Shearon Harris Nuclear Power Plant, Unit 1  
Docket No. 50-400  
Renewed License No. NPF-63

**Subject:** Response to Second Request for Additional Information Regarding License  
Amendment Request for Temporary Changes to Technical Specifications for the  
'A' Emergency Service Water Pump Replacement

**RESPONSE TO REQUEST FOR ADDITIONAL INFORMATION**

PROJECT: HARRIS NUCLEAR PROJECT - UNIT 1  
 DRAWING NO.: CPL-2165-S-0547  
 SHEET: 1 - UNIT 1

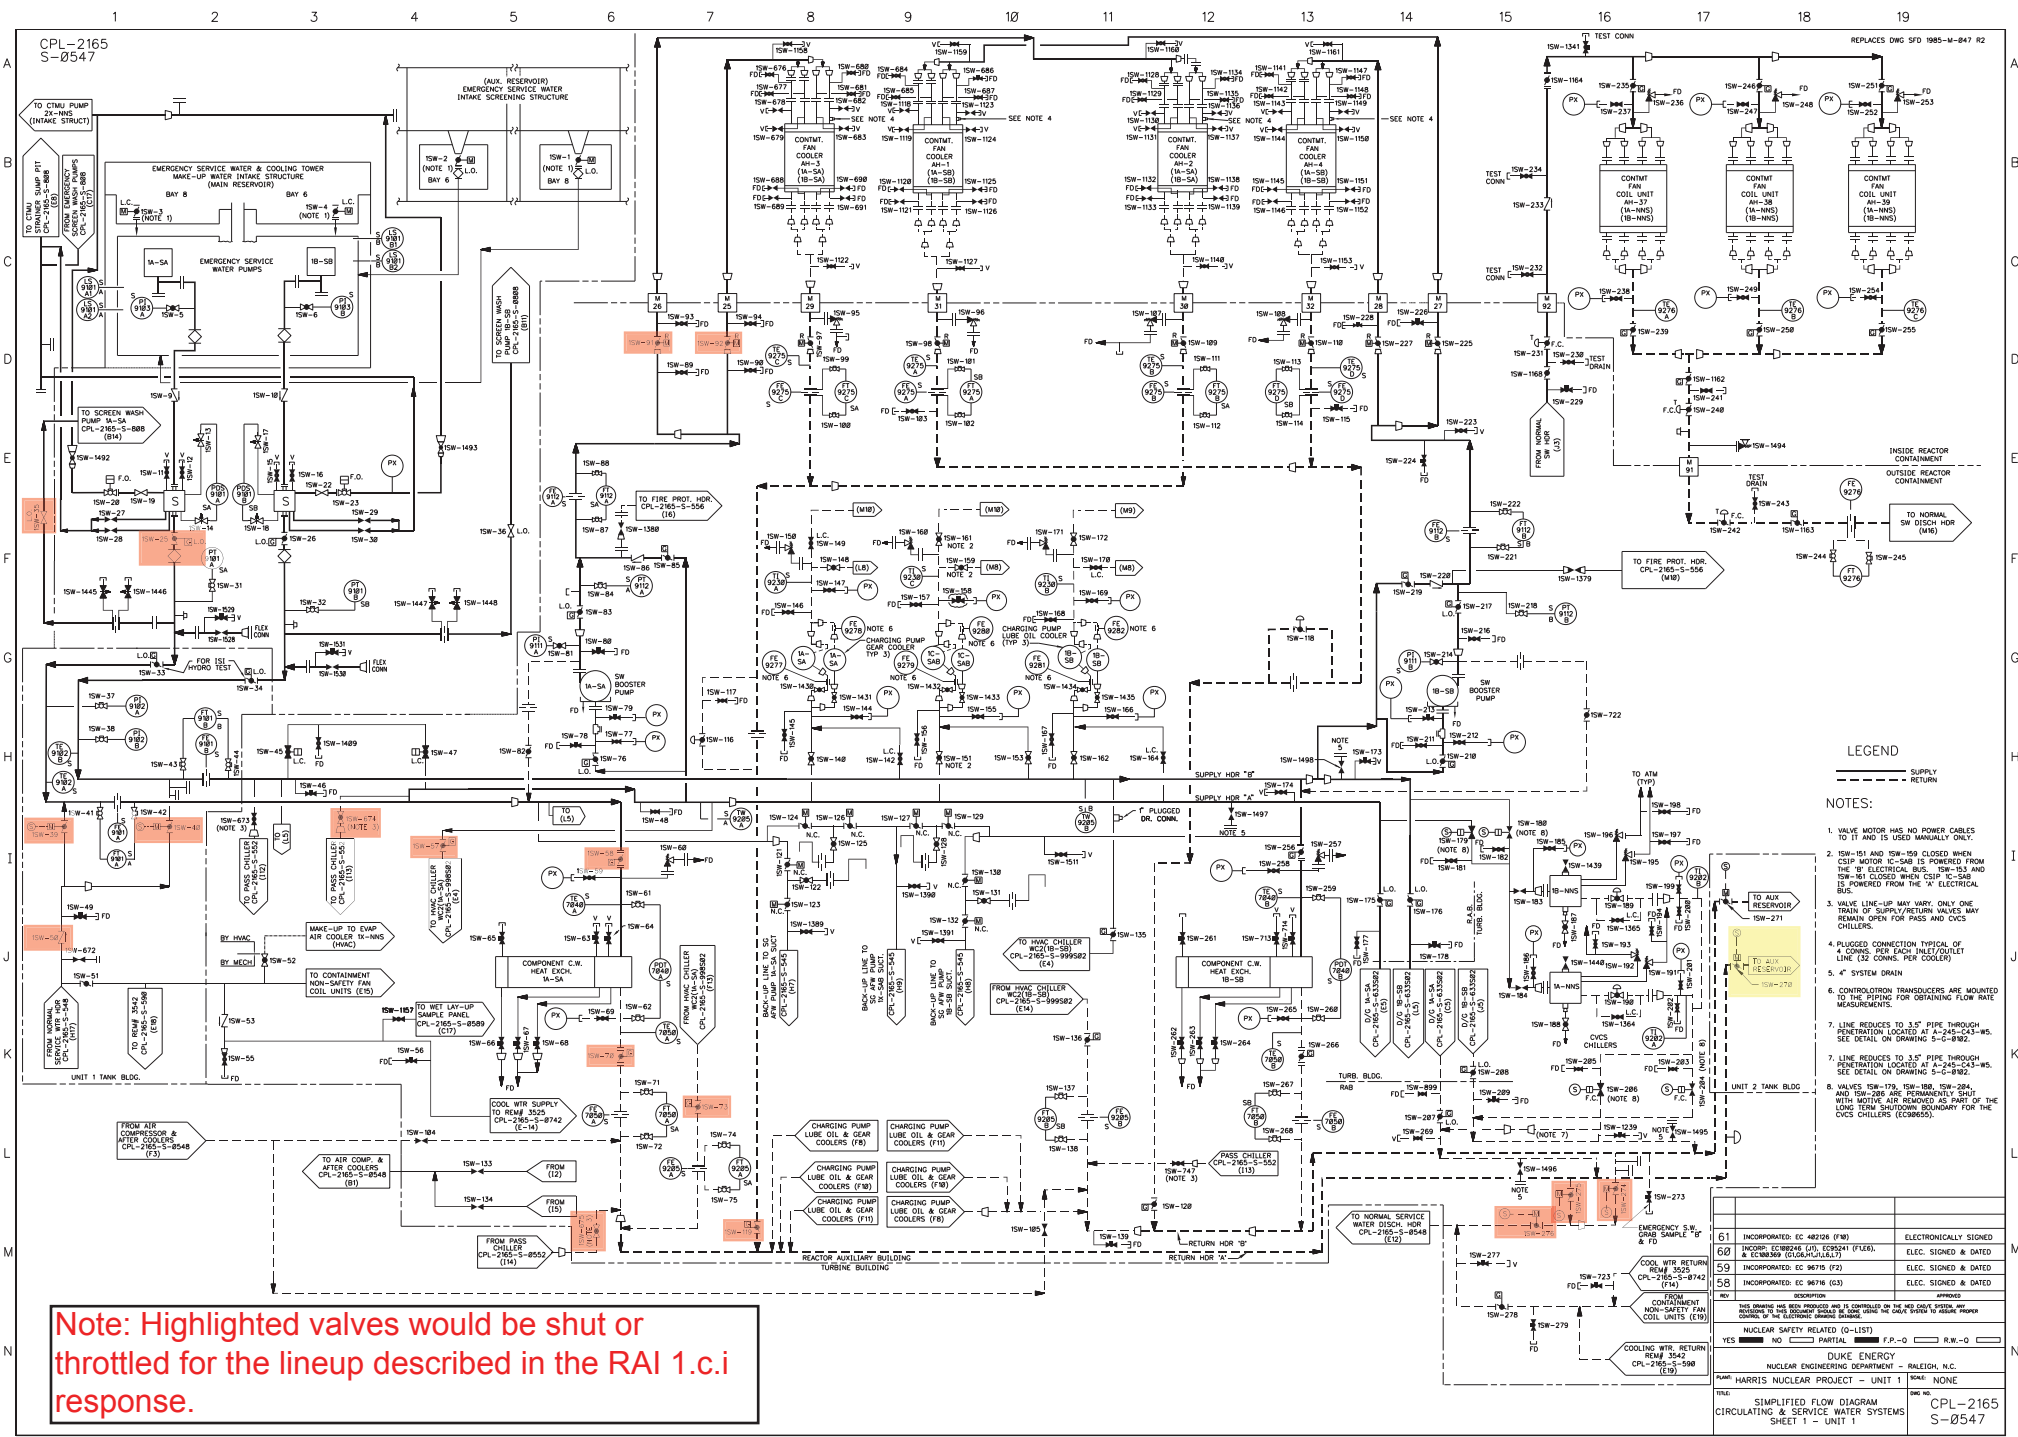
- i. Describe the ESW flow path to the operating EDG and other essential loads using the FLEX pump. Include a description of valve repositioning(s) necessary to support the cooling water lineup, including the valve manipulation(s) necessary to ensure water inventory only goes to the intended loads, and the estimated time needed to accomplish the lineup.

- c.i. The valve lineup to accomplish this has been reviewed and personnel will be trained and available to execute the necessary isolations of other 'A' ESW loads, shown below, within a one-hour time frame. Attachment 5 of this submittal contains a simplified flow diagram of the circulating and service water systems that shows these valves for additional reference. Additional operator staff will be utilized. Operators will be trained and staged to support the necessary valve isolations. The 'A' EDG would be manually started to support the 'A' CSIP and 'A' AFW pump. The 'A' motor driven AFW pump and TDAFW pump will remove decay heat through the steam generators to transition the unit to hot shutdown.

Isolate (shut) normally-open 'A' ESW loads:

Load	Action
ESW Screenwash	Shut 1SW-35
ESW Pump Discharge	Shut 1SW-25 (will already be shut as part of 'A' ESW Pump replacement)
Normal (Non-Safety) Service Water Supply	Shut 1SW-39, 40 (check valve 1SW-50 will also provide isolation)
Normal (Non-Safety) Service Water Return	Shut 1SW-275, 274, 276
Post-Accident Sampling System Chiller	Shut 1SW-674, 675
Containment Fan Coolers	Shut 1SW-91, 92, 119
Essential Services (Safety) Chilled Water	Shut 1SW-57, 73
Component Cooling Water HX	Shut 1SW-58, 70 (will be opened later to provide SFP and letdown HX cooling)
ESW Return to Aux. Reservoir	Throttle 1SW-270 (need to throttle to keep ESW header pressurized)

Note: Highlighted valves would be shut or throttled for the lineup described in the RAI 1.c.i response.
